WILSON PARK
Summit St. & Birch St.
Fall 2006

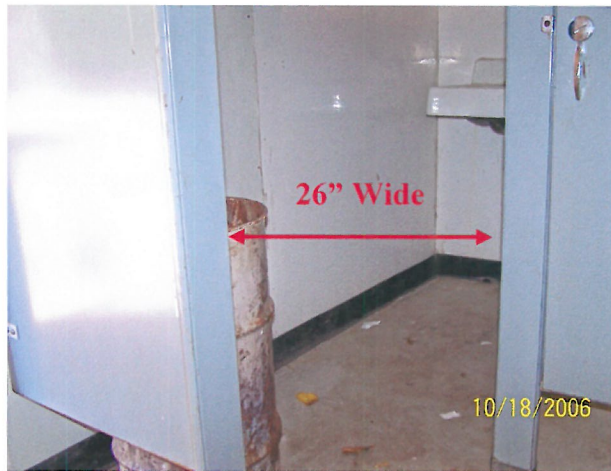
There is enough wall space in the men's restroom to widen the toilet stall. The urinal rim is too high and the lavatory has round faucet controls and exposed drain pipes.

- Toilet stalls are too narrow (47" wide) to allow adequate space for wheelchair users.	See recommendations.	M		The men's restroom has enough extra wall space to move fixtures to accommodate a standard stall as per 4.17. The alternative is to modify one restroom as an accessible "unisex".
